MAYOR & COUNCIL COMMUNICATION

AGENDA ITEM: Northeast Metro Intermediate School District 916 Preliminary and Final Plat and PUD Development Plans

City of Lake Elmo Planning Department
Preliminary & Final PUD Plan/Plat

To: Ben Gozola, Senior Planner, Sambatek
Cc: Kyle Klatt, Planning Director
From: Jack Griffin, P.E., City Engineer
Re: ISD 916 Intermediate School Building
Final Plat/Construction Plan Review

Sheet No. 200.CU

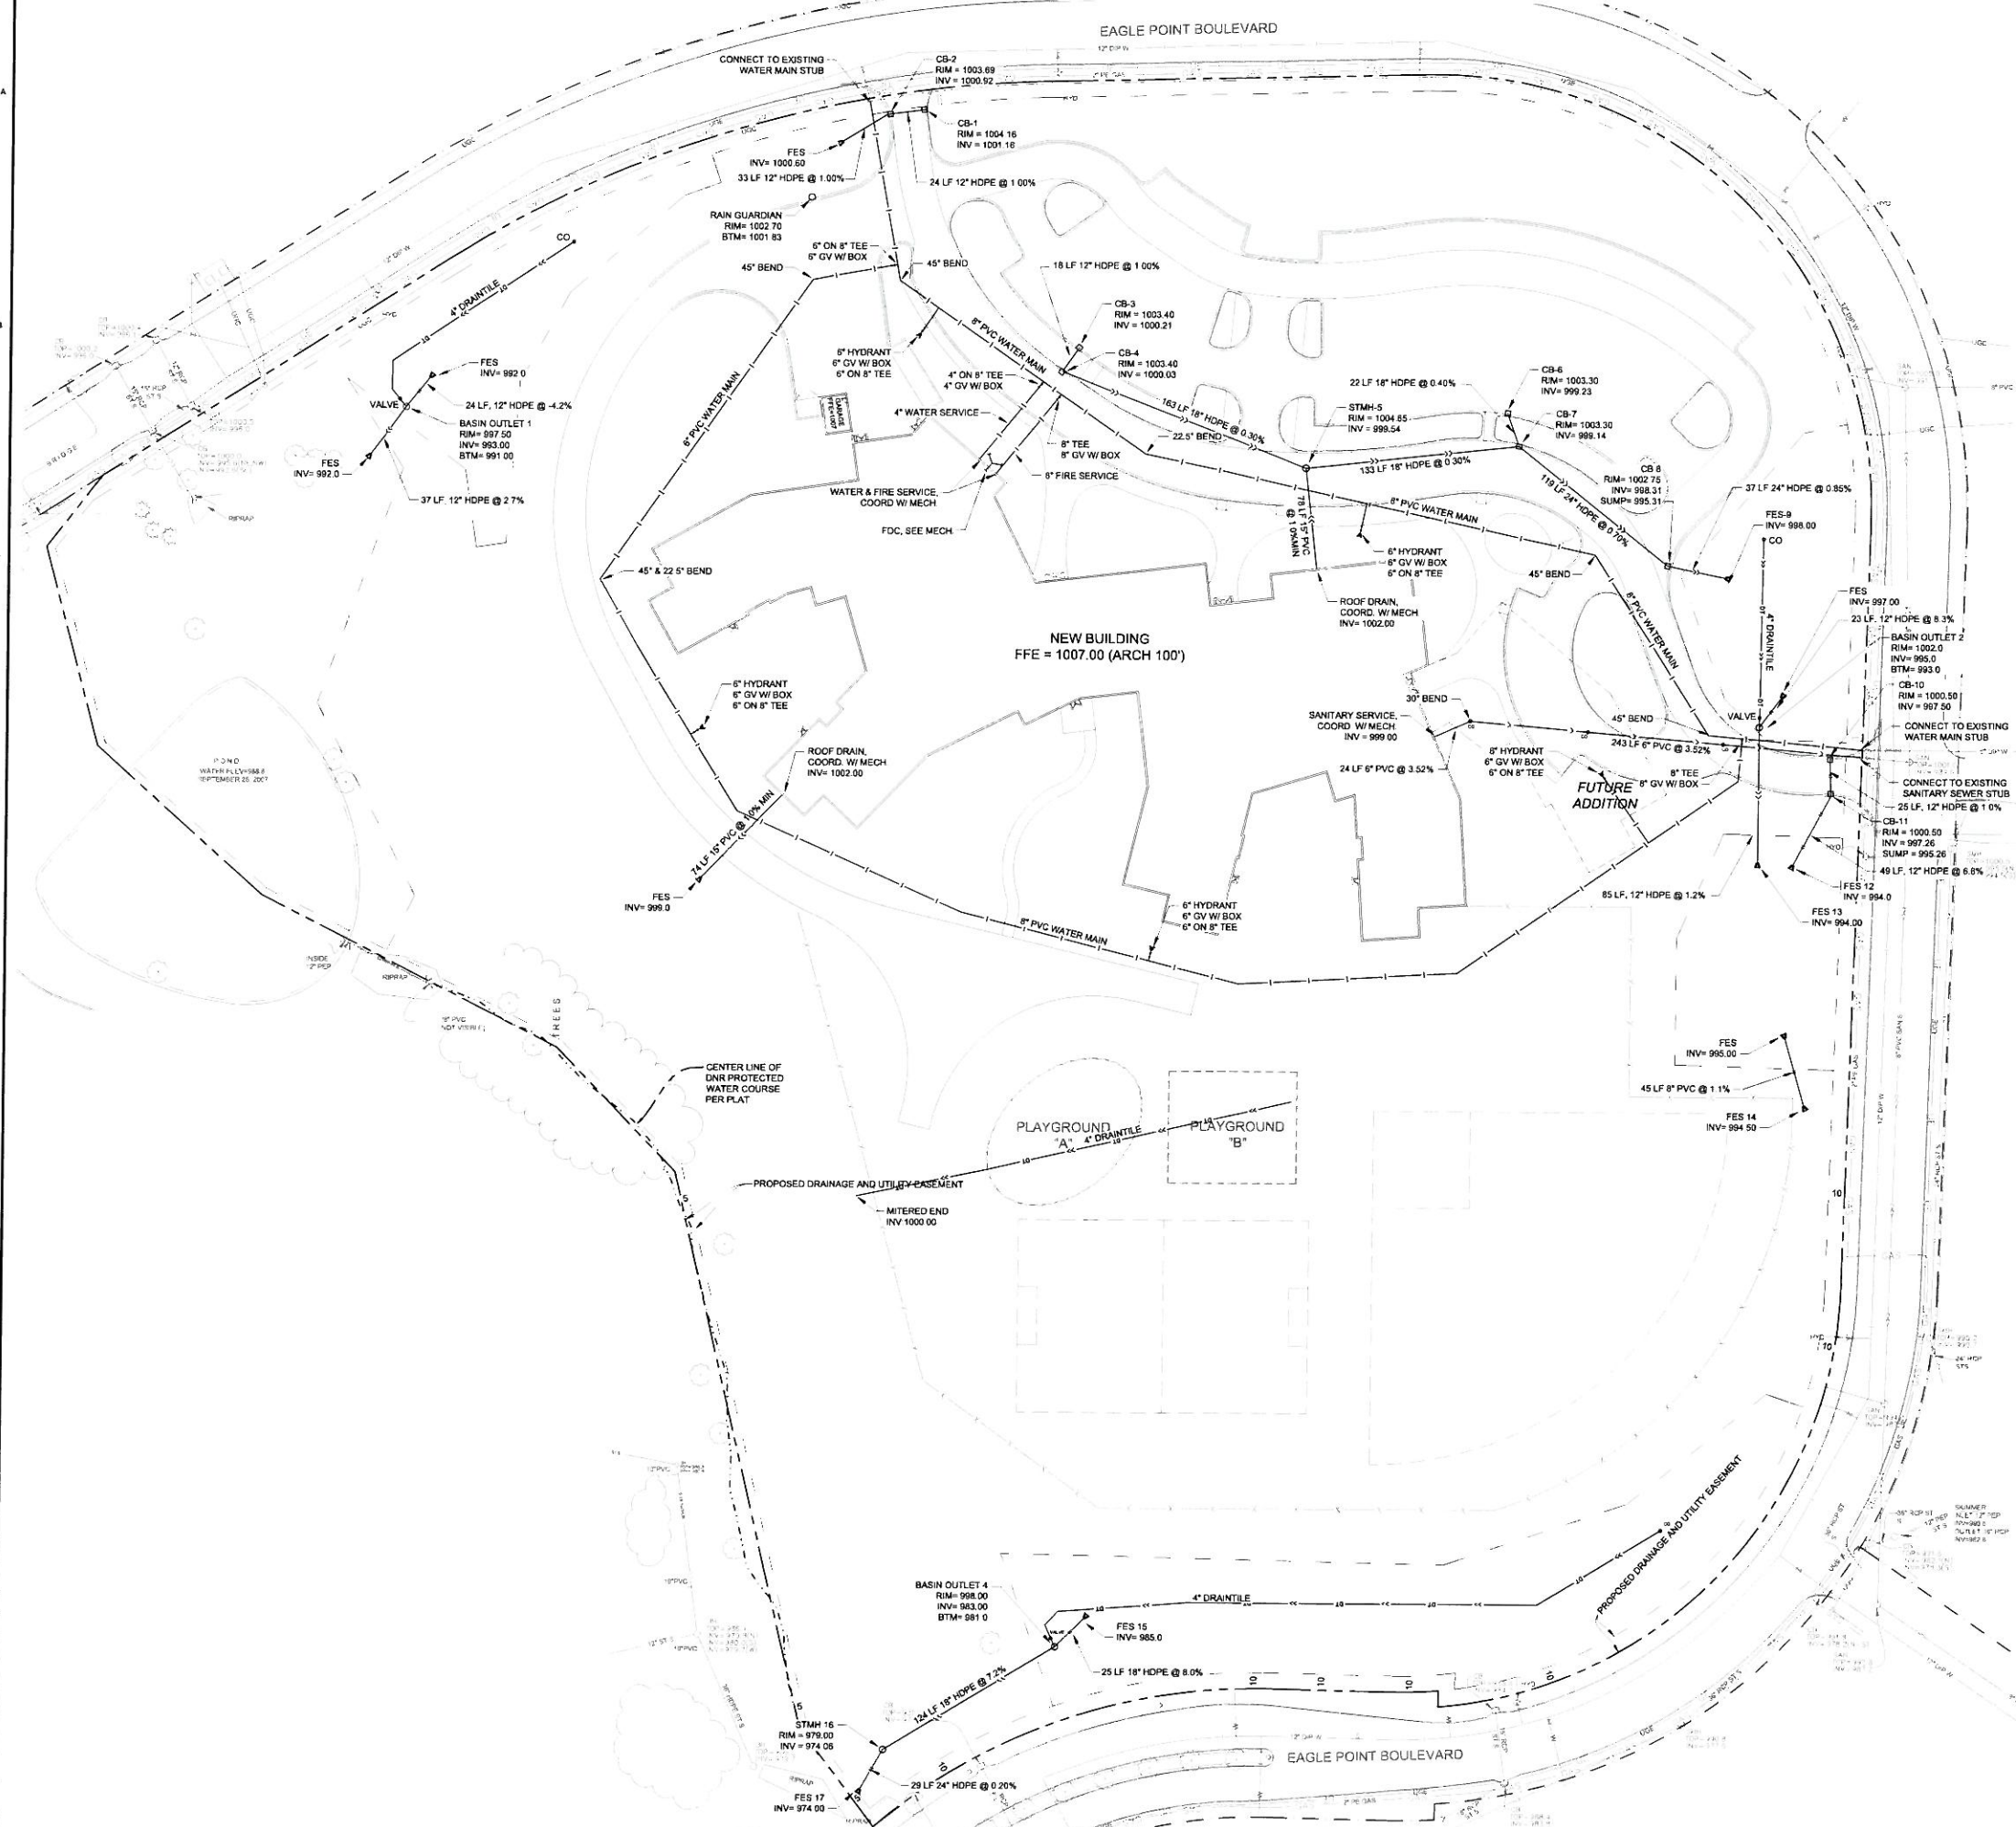
6. Sheet 200 CU:
- Connection to existing sanitary sewer stub. The project proposes to connect to the existing 8-inch sanitary sewer stub located in Eagle Point Boulevard. A 6-inch private service line is proposed to connect to the building. No public utilities are proposed.

- Connection to existing watermain stub. The project proposes to connect to an existing 12-inch watermain at two locations within Eagle Point Boulevard to create a looped watermain network. In addition, an 8-inch watermain is also proposed interior to the site and looped around the building with 5 hydrants for fire protection. A 4-inch water service line and 8-inch fire service line are proposed to connect to the building (private service lines). The interior site watermain loop with hydrants must be publically owned and maintained. Easements must be provided as part of the revised Plat.

- The City minimum pipe size is 8inch. The 6-inch watermain shown on the northwest side of the building must be revised to 8-inch pipe.
 - City Standard Plan Notes for Watermain must be included on the Utility Plans. Any plan notes that contradict the City plan notes must be removed.
